Omaha Public Power District

August 31, 1981

The Commission's letter dated May 13, 1981, requested additional information regarding the adequacy of Fort Calhoun Station's electrical distribution system voltages. The District's submittal dated July 2, 1981, provided responses to Questions A, B, and C of the Commission's letter, while responses to Questions D and E were to be provided at a later date. The District's response to Questions D and E is attached.

Test and Analytically Derived Voltages at
Bus 1B4B During Class 1E Motor Starting
Transient Tests

Motor Terminal Voltage
CalculationsSH 2 CONT ON SH 3OMAHA PUBLIC POWER DISTRICT
GENERATING STA ENG1) One Line Diagram: (Refer to Fig. 8.4-1 FSAR)

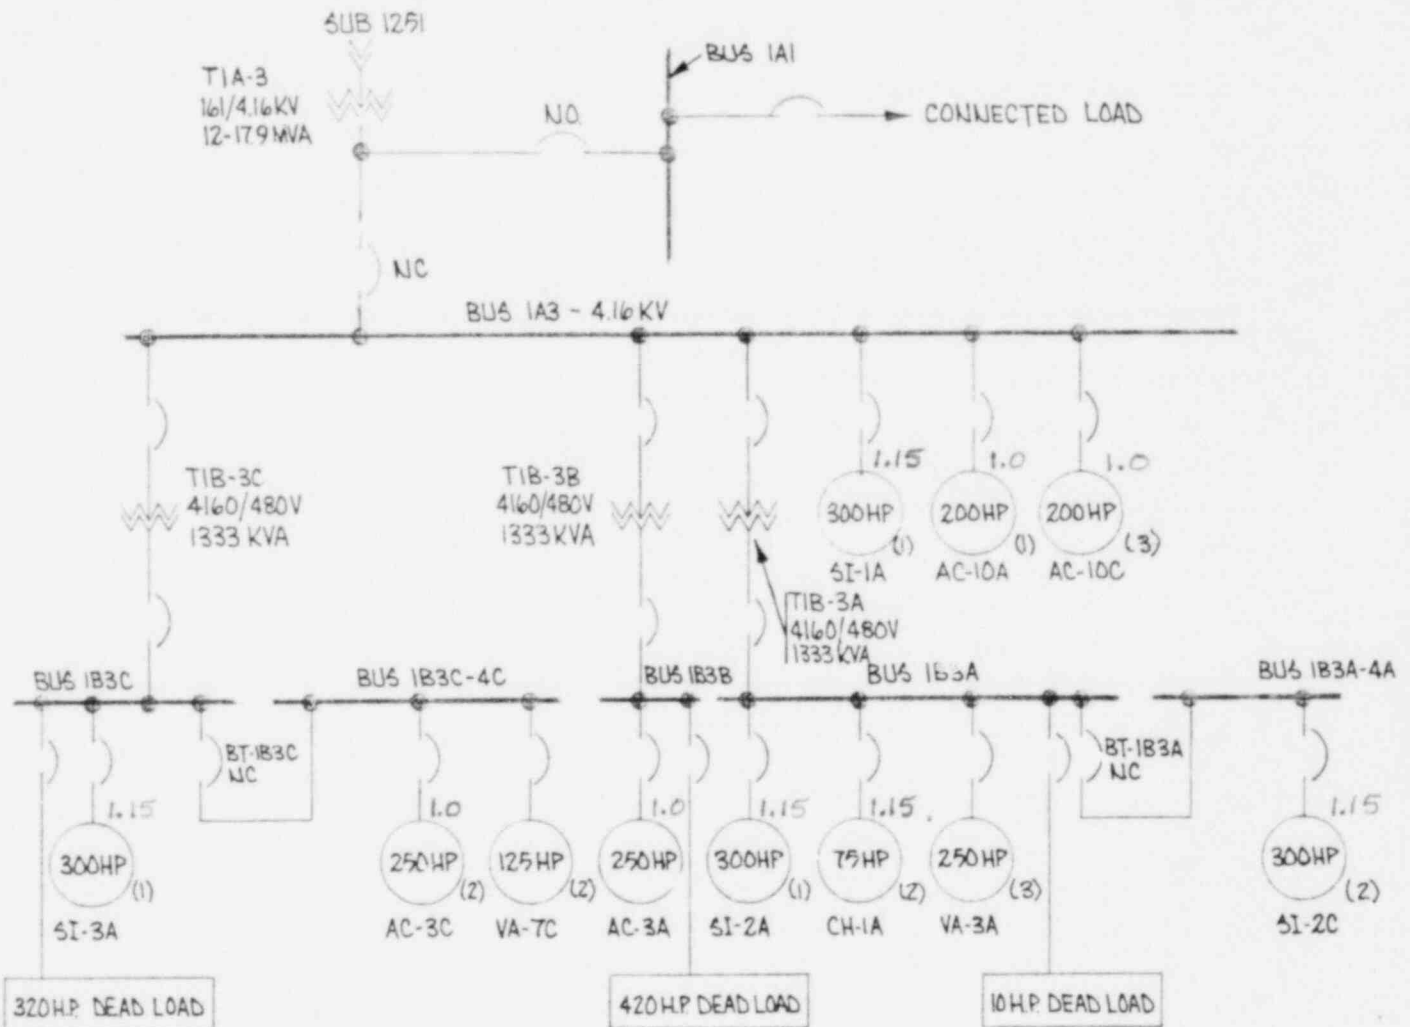
What is the service factor for the 4160V, 4000V and the 460V safeguards motors?

Enclosure 1 provides a complete listing of motor service factors (except for ventilation air fan motors VA-3A, VA-3B, VA-7C, and VA-7D) for the 4160V, 4000V, and 460V safeguards motors. Custom built, high efficiency motors such as VA-3A, VA-3B, VA-7C, and VA-7D are manufactured without motor service factors because they are designed and used for a specific function.

Service Factors in green, (See Question D).
(The VA motors do not have a manufacturer specified service factor)

Motor Terminal Voltage
CalculationsSH 2 CONT ON SH 3OMAHA PUBLIC POWER DISTRICT
GENERATING STA ENG1) One Line Diagram: (Refer to Fig. 8.4-1 FSAR)

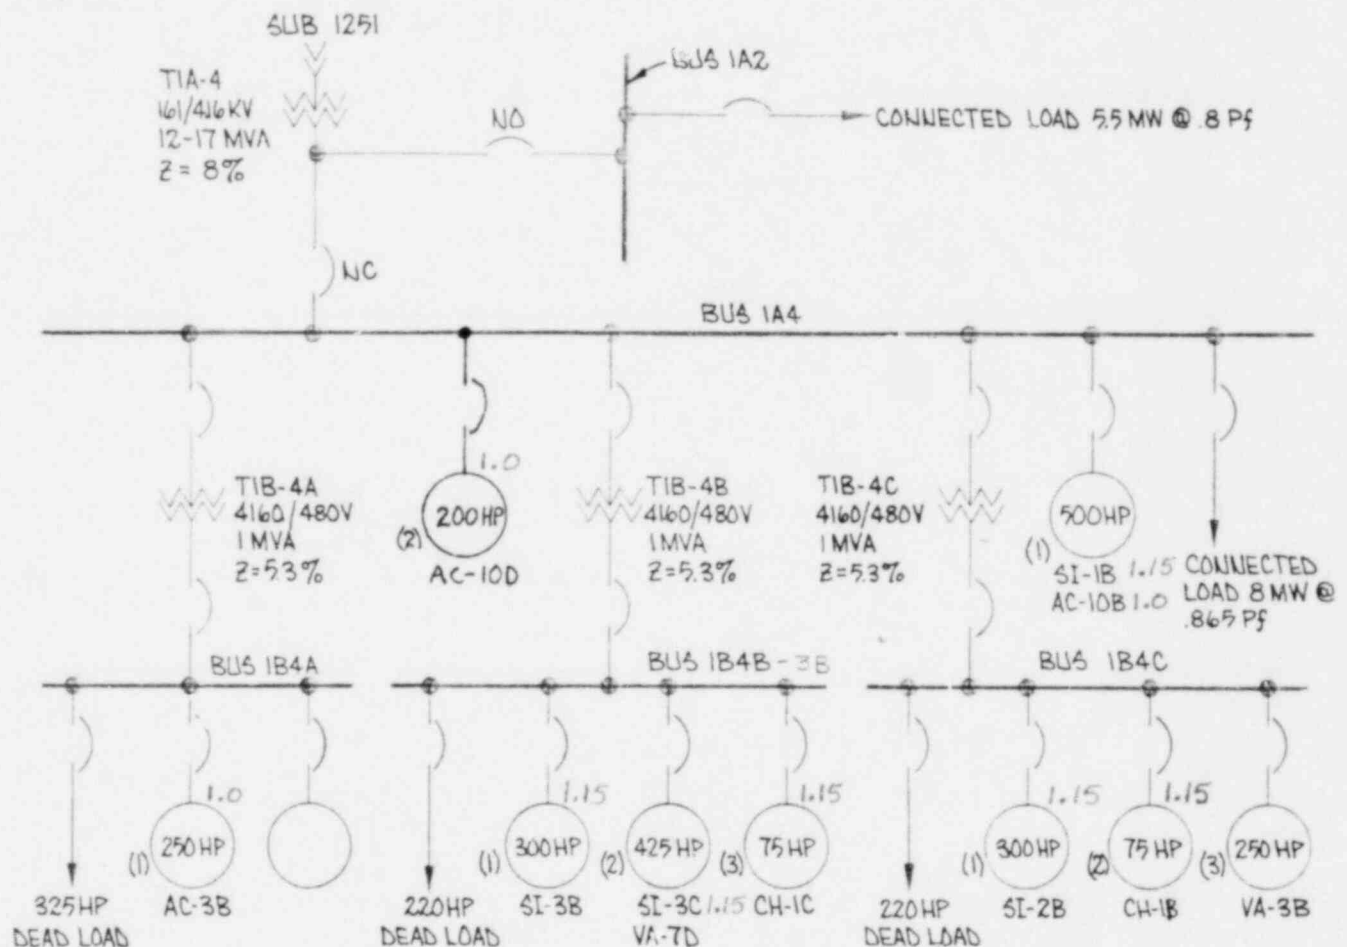
The NRC letter of August 8, 1979 requires a test be performed to verify your analytical results. The latest guidelines required that this test should be performed by:

- (a) Loading the station distribution buses, including all Class 1E buses down to the 120/208V level, to at least 30%;
- (b) Recording the existing grid and Class 1E bus voltages and bus loading down to the 120/208 volt level at steady state conditions and during the starting of both a large Class 1E and non-Class 1E motor (not concurrently);

Based on the District's previous undervoltage analysis, bus 1B4B was determined to have the lowest analyzed voltage. Therefore, only transient voltage measurements on bus 1B4B were recorded. Two separate motor starting tests were conducted with Class 1E motors to provide voltage data. This test data was then compared to the analytically derived voltages for bus 1B4B. The first test involved starting the 300 HP containment spray pump SI-3B. The second test involved the concurrent starting of two motors, containment spray pump SI-3C and ventilation air fan motor VA-7D, with combined power requirements of 425 HP. The compared results of the voltage test measurements and of the analytically derived voltages at bus 1B4B for both transient tests are summarized in Enclosure 2. Voltage values above the 480V level were not analyzed as recording equipment measuring transient voltage changes on the distribution grid (161 KV) and bus 1A4 (4.16 KV) measured no detectable voltage drops when the motors were started.

Comparison of the test and analytically derived voltage values in Enclosure 2 revealed the test voltages to be higher than the calculated voltages. The calculated voltage of 429V for the motor starting analysis of SI-3B was found to be 3.8% lower than the measured test voltage of 446.2V. The calculated voltage of 421V for the concurrent motor starting analysis of SI-3C and VA-7D was found to be 3.5% lower than the measured test voltage of 436.5V. The District believes the resultant correlations of 3.5% and 3.8% are sufficient evidence to justify the validity of our analytical model and that no further testing is required. Selected variable values (e.g., motor locked rotor factors) used in the calculation of the analytically derived voltages were conservative and probably accounted for the differences. It is believed that the use of less conservative variable values would result in closer correlations between analytical and test results.

Service Factors in green.
